SUNDRY NOTICES AND REPORTS ON WELLS

EUNICE MONUMENT 626

30-025-31465

XTO WOULD APPRECIATE AN EXTENSION TO THE TA'D STATUS OF THIS WELL AT THIS TIME.

MIT CHART ATTACHED - GOOD.

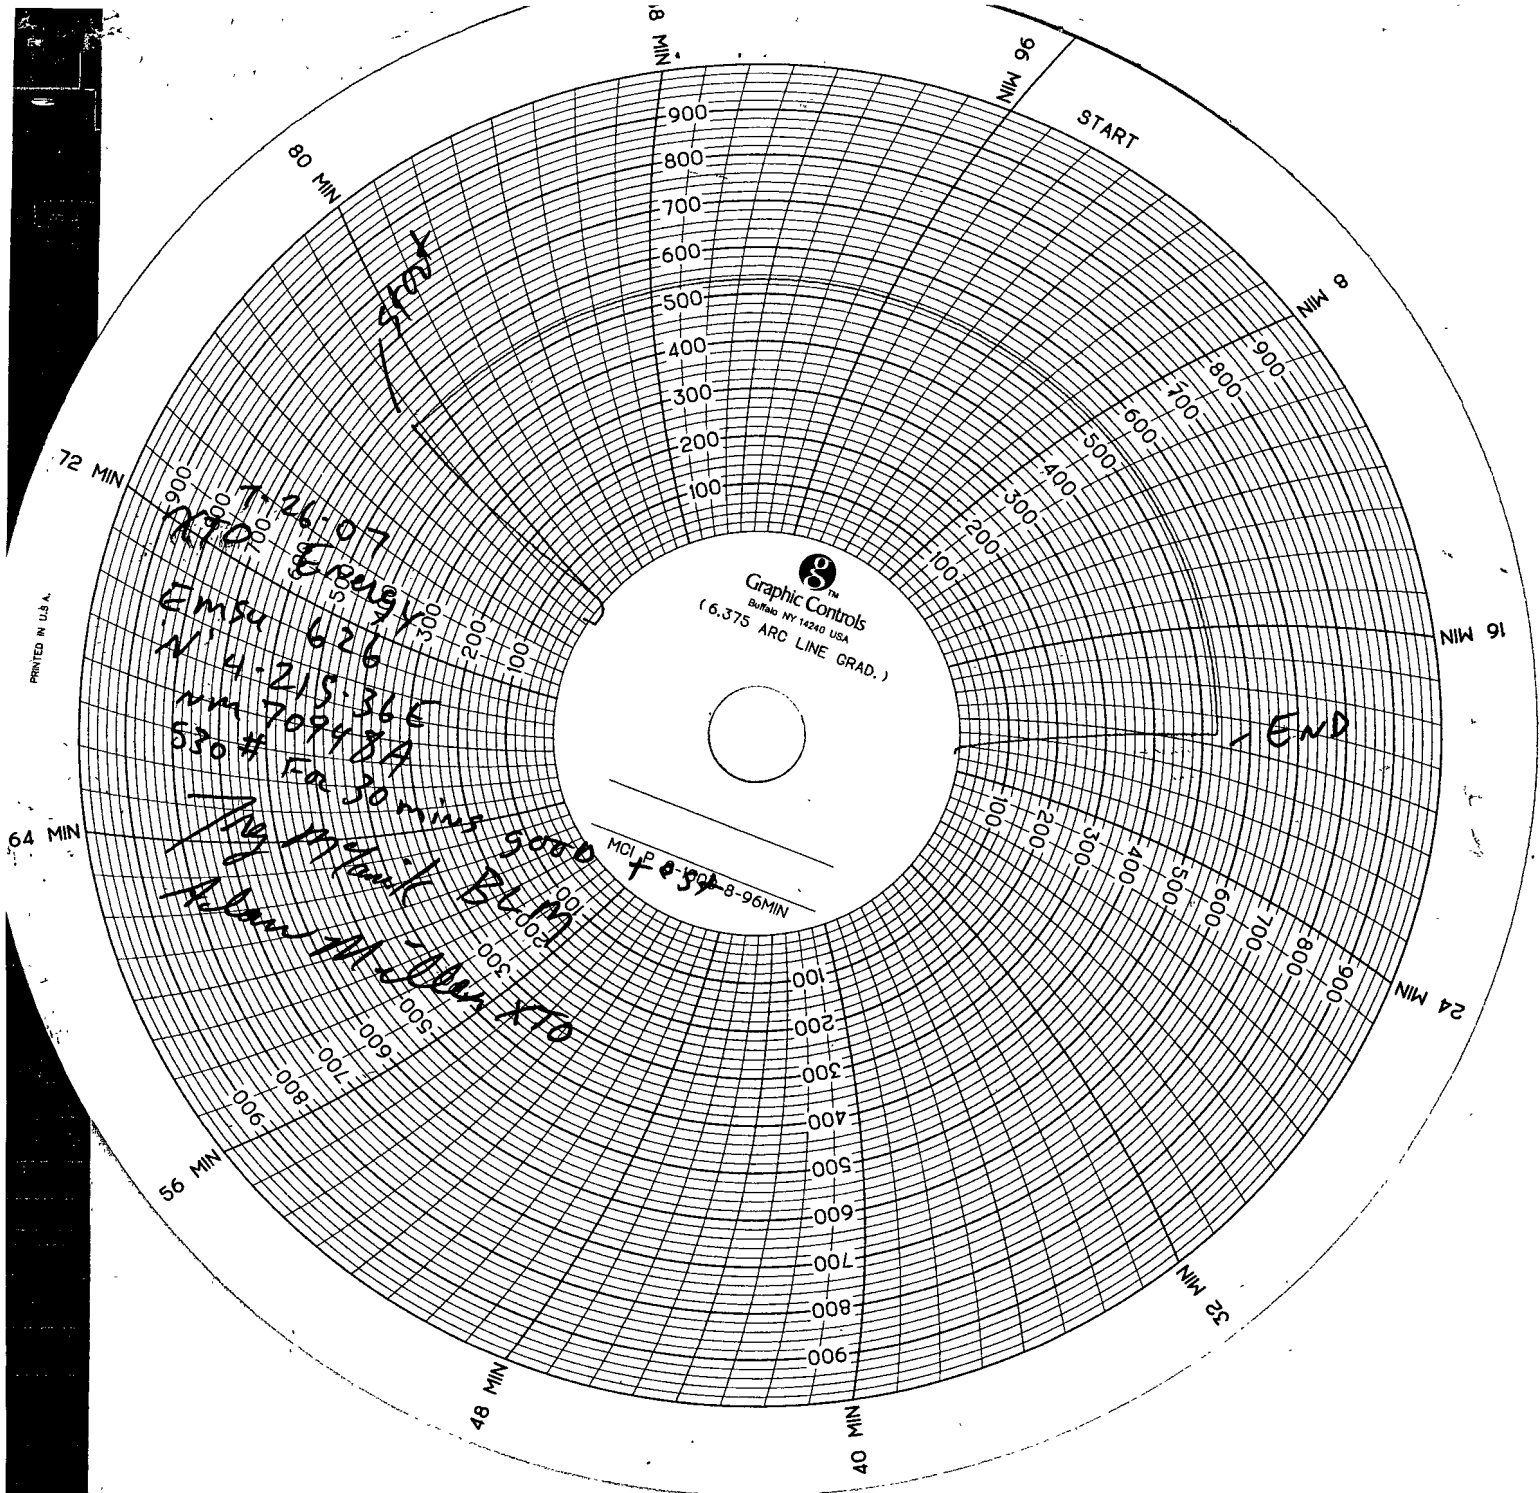
T-26-07
Emsa 626
N' 4-215-366'
mm 70948A
530 #
For 30 mins
